**CULTURAL RESOURCES OFFICE
PRESERVATION BOARD
REGULAR MEETING
MONDAY APRIL 22ND, 2019 — 4:00 P.M.
1520 MARKET ST. #2000, ST. LOUIS, MO. 63103
www.stlouis-mo.gov/cultural-resources**

DATE: April 22, 2019
ADDRESS: 1022 S. 18th Street
ITEM: Preliminary Review: Construction of a single-family house
JURISDICTION: Lafayette Square Local Historic District — Ward 6
STAFF: Jan Cameron, Cultural Resources Office

DATE: April 22, 2019
ADDRESS: 3318 Lemp Avenue
ITEM: Preliminary Review: request for reconsideration of Preservation Board condition of preliminary approval
JURISDICTION: Benton Park Local Historic District — Ward 9
STAFF: Jan Cameron, Cultural Resources Office

DATE: April 22, 2019
ADDRESS: 2300 LaSalle Street
ITEM: Preliminary Review: Construct Mixed-Use Building
JURISDICTION: Lafayette Square Local Historic District — Ward 6
STAFF: Daniel Krasnoff, Cultural Resources Office

STREETSCAPE ELEVATION

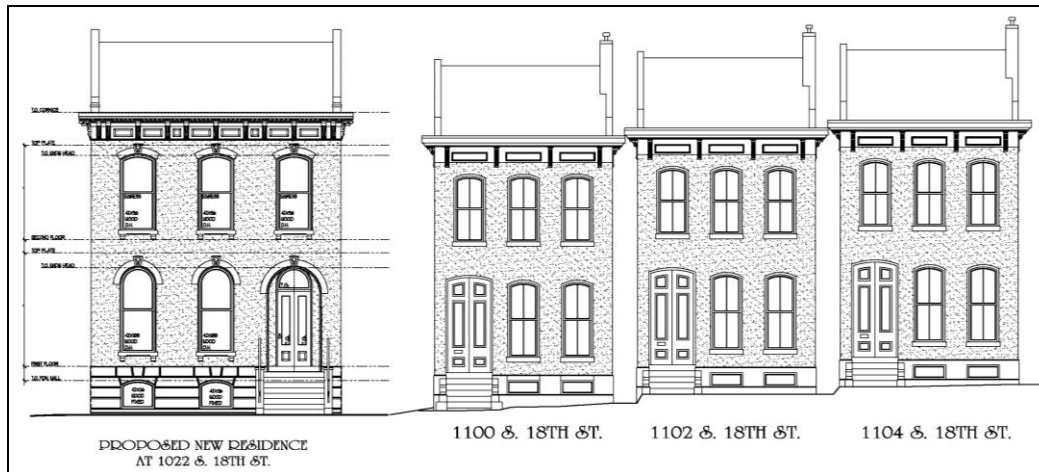
Complies. However, the uniformity of Harris Row emphasizes the proposed design's deviation in scale, height, and the proportions of individual elements.

The form of the roof is similar to the HME in that it has a cross-gable in the front and a flat roof at the rear. However, the proportions of the gable do not follow the HME or any of the Harris Row houses.

- Based on the Preliminary findings, the Cultural Resources Office recommends that the Preservation Board grant preliminary approval to the design as currently presented with the condition that the cornice and foundation return and window arches and sills of the north elevation be revised to more closely follow the HME; that entry be detailed with an appropriate transom, transom bar and paneled reveals; and that the glass areas of the rear facade be screened with an appropriate 2-story porch.

HISTORIC MODEL EXAMPLE

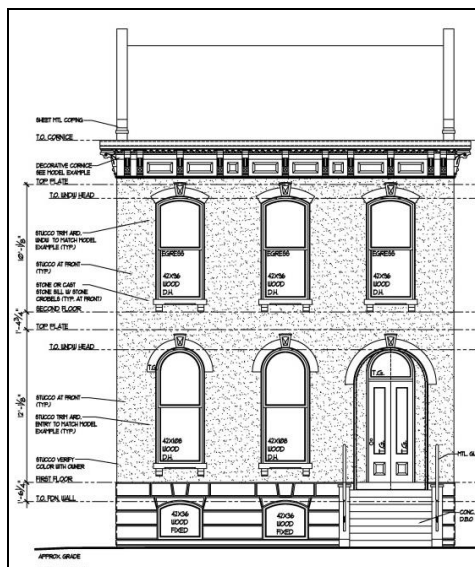
Partly complies. The openings originally proposed have been reduced in scale to more closely follow the HME, and placed in bays on the north elevation. However, the north elevation does not follow the HME, which has paired windows on three floors and a rear wing of more closely set window bays.

Does not comply. The rear elevation is entirely exposed to street view and here a number of large openings are proposed at both the first and second stories. They are contemporary in size and arrangement and are not based upon the HME.

Partly complies. The doorway height is appropriate. However, details of the entry have not been submitted; the elevation shows no transom bar or paneled reveals.

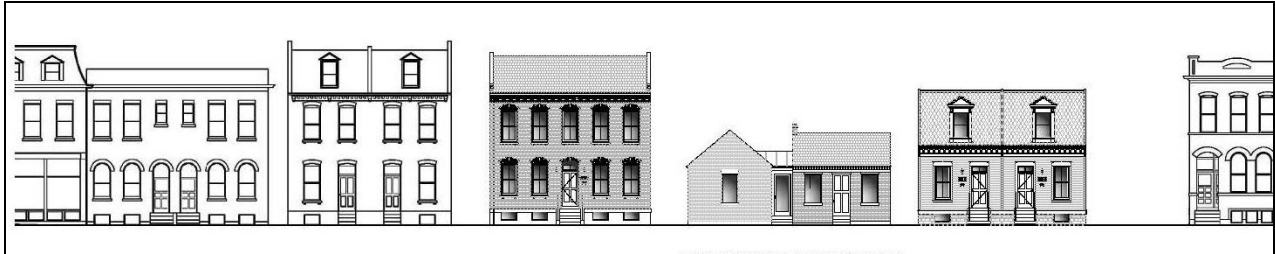
Complies. 3318 Lemp will have a brick front façade; side elevations will have brick returns, with the remainder of the façade sheathed in composite lap siding.

Based on the Preliminary findings, the Cultural Resources Office recommends that the Preservation Board grant preliminary approval for the new construction, with the stipulation that the brick returns on each side elevation be increased; that small windows on the north elevation be redesigned; and that final drawings, materials and colors are reviewed and approved by the Cultural Resources Office.

PERSPECTIVE OF NORTH ELEVATION

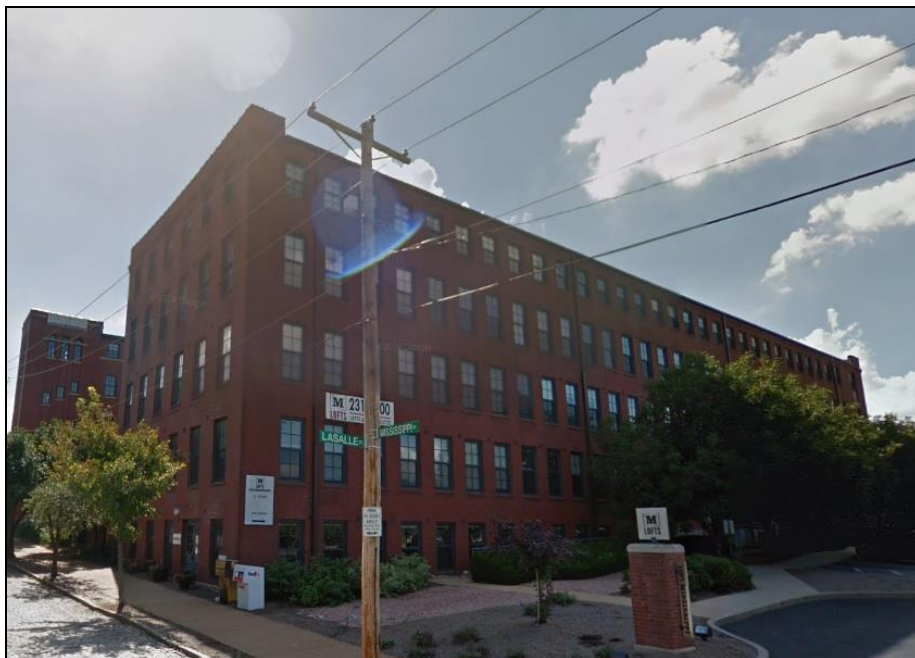
Mostly complies—there are some horizontal corten steel panels that are used in the design, but are not a primary building material.

Does not comply. The HME requirement for a site with so little context does not require replication of design elements.

Based on the Preliminary findings, the Cultural Resources Office recommends that the Preservation Board grant preliminary approval to construct the mixed- use building with final design details completed in coordination with Cultural Resources Office staff.

2300 LASALLE – SITE PLAN

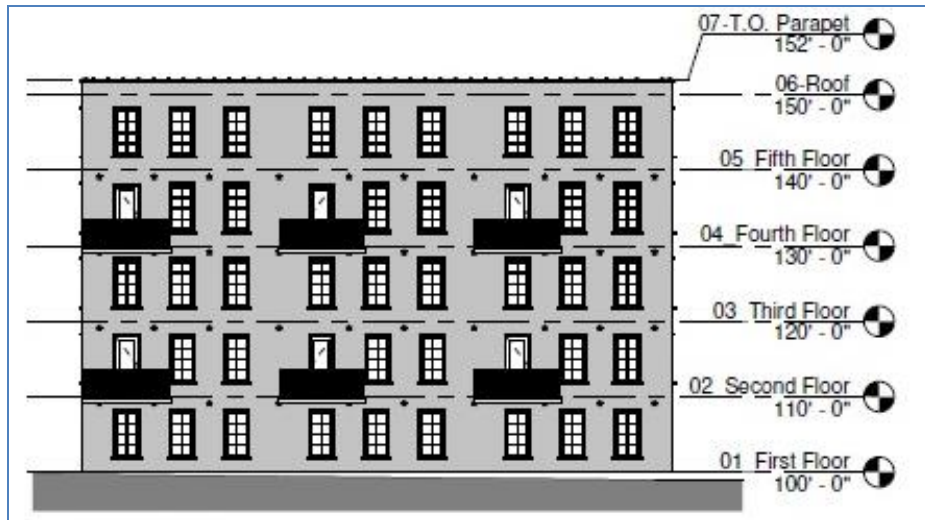
Mostly complies. Parking islands are slightly smaller than the required 9-foot width.
